Subject: Addendum to *Preliminary Site Assessment/Soil, Soil Gas and
Groundwater Investigation Work Plan*
Former Regal Station #120, LOP Case No. RO0002875
3875 Telegraph Avenue, Oakland, California

On behalf of our client Wickland Corporation (Wickland), West Environmental Services & Technology, Inc. (WEST) has prepared responses to the Alameda County Health Care Services Agency, Environmental Health Division (ACEH) technical comments to the *Preliminary Site Assessment/Soil, Soil Gas and Groundwater Investigation Work Plan* for the former Regal Station #120 (Local Oversight Program Case No. RO0002875), located at 3875 Telegraph Avenue in Oakland, California ("the Site"). The responses were prepared to address the September 6, 2007 ACEH technical comments and the comments made by the ACEH during the October 2, 2007 meeting with Wickland and WEST. The responses are interlineated below with the ACEH comments and will be incorporated by addendum to the *Preliminary Site Assessment/Soil, Soil Gas and Groundwater Investigation Work Plan*.

Figure 5-1

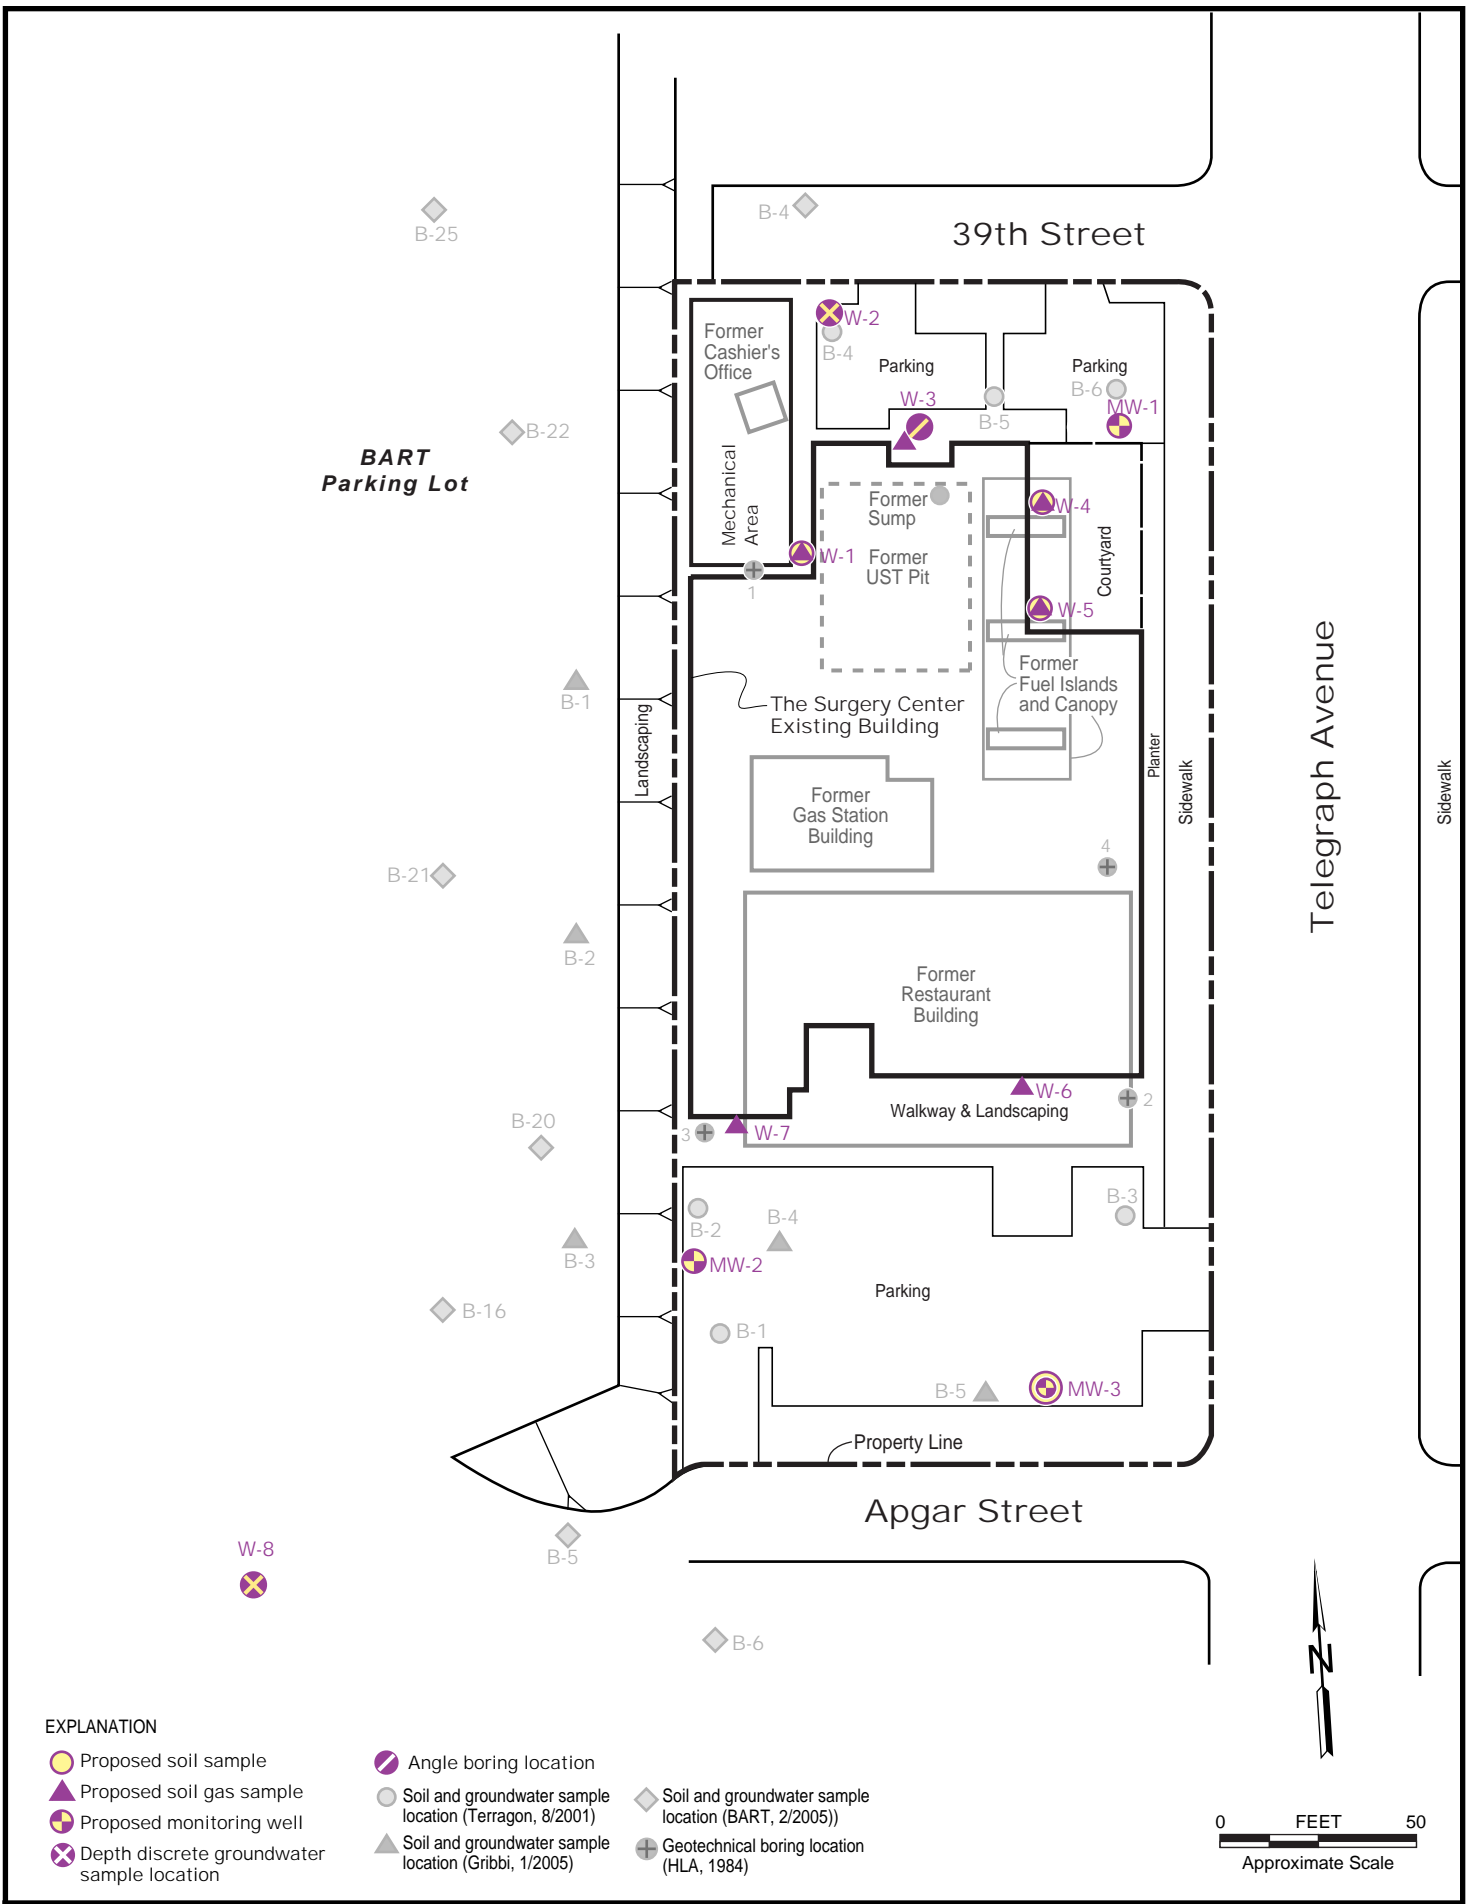
Potential for Vapor Intrusion and Proposed Soil Vapor Sampling Locations. The Work Plan currently proposes soil vapor sampling at four locations outside the existing building. The existing building is constructed above the former UST pit and former fuel islands, which are likely sources of fuel releases. In order to evaluate potential vapor intrusion in the areas most likely to be impacted, we request that you include subslab vapor sampling inside the existing building in the Revised Work Plan requested below. In addition, we request that you propose additional soil vapor sampling to evaluate other suspected sources.

Soil and Groundwater Sampling in Source Areas. The former UST pit and former fuel islands, most of which are beneath the existing building, are likely source areas. Limited characterization is currently proposed in the area of and downgradient from these likely sources. Please propose additional activities to evaluate the likely source areas or present some rationale and justifications for not conducting soil and groundwater sampling in the likely source areas. Please include this information in the revised Work Plan requested below.

Proposed Boring W-3. The Work Plan proposes the installation of boring W-3 and well MW-1 at closely spaced locations upgradient of the likely source areas. These locations are also adjacent to boring B-6 in which one soil sample and one grab groundwater sample were previously collected. We recognize the value of an upgradient monitoring well; however, we do not see the added value of proposed soil boring W-3 in this upgradient location. Please review this proposal in the Revised Work Plan requested below.

With regard to the southern portion of the Site, Wickland did not operate on this portion of the Site. However, as presented in the *Work Plan*, WEST proposes to install two groundwater-monitoring wells on the accessible areas of the southern portion of the Site (Figure 5-1). Based on the discussions, which occurred during the October 2, 2007 meeting, WEST proposes to conduct a survey of the areas near the proposed groundwater monitoring well locations during its underground utility clearance activities. The underground utility locating equipment which includes a metals detector will be used to identify potential subsurface metallic anomalies within the accessible areas on the southern portion of the Site.

Based on the observations made during a Site inspection conducted by WEST and Gribi Associates on September 26, 2007 and discussed at the October 2, 2007 meeting, it is not feasible to conduct subslab vapor sampling. However, WEST proposes to collect an additional soil gas sample, W-3, from the area adjacent to the northern portion of the building to evaluate the potential for vapor intrusion. The soil gas sample location, W-3, is presented on revised Figure 5-1 (Attached). Based on the soil gas analytical results, additional sampling may be recommended.

Due to the presence of the East Bay Surgery Center building, there are limited areas to conduct soil and groundwater sampling in the vicinity of the former USTs and fuel islands on the northern portion of the Site. However, as discussed above, WEST proposes to collect an additional soil gas sample adjacent to the building. In addition, as discussed at the October 2, 2007 meeting, WEST proposes to advance an angle boring, W-3, near the northern edge of the East Bay Surgery Center to collect additional soil and groundwater samples near the former USTs (Table 5-1, attached).

The location of the additional soil gas sample and the angle boring are presented on the revised Figure 5-1 (Attached).

As discussed above, WEST proposes to advance an angle boring, W-3, to a depth of 25 feet vertically from the ground surface near the northern edge of the East Bay Surgery Center building. Soil and groundwater samples will be collected from the angle boring to generate data for characterizing the subsurface conditions near the former sump and USTs.

WEST will relocate boring W-3 near the northern edge of the East Bay Surgery Center and advance as an angle boring, as discussed above, to collect soil and groundwater data near the former USTs and sump (revised Figure 5-1; attached).
